Product Change Notification (PCN)

PCN #: 7B-2020   *DATE: 7/22/2020*

2 DESCRIPTION OF CHANGES:

5.1 Top Level Part Number Changes (packaged kits)

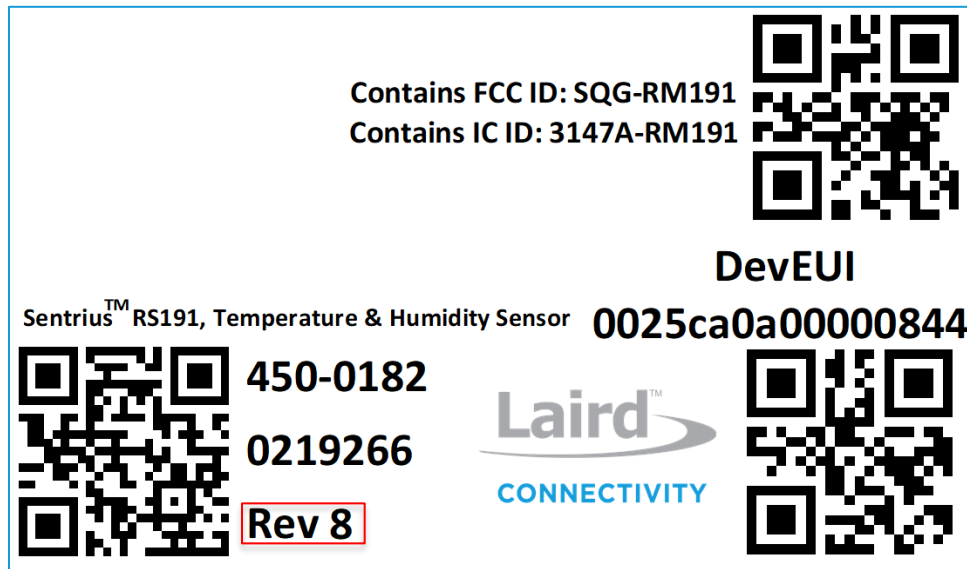
- Latest revision changes available as revision number printed on kit content label for all kits (Label located on the bottom left corner of the base kit label). Specific kit part number and revision printed on the label within red square area.

Note: Label located on the bottom right corner of the kit base label contains the same label info as printed on the sensor contained within the specific kit (On Sensor Changes section).
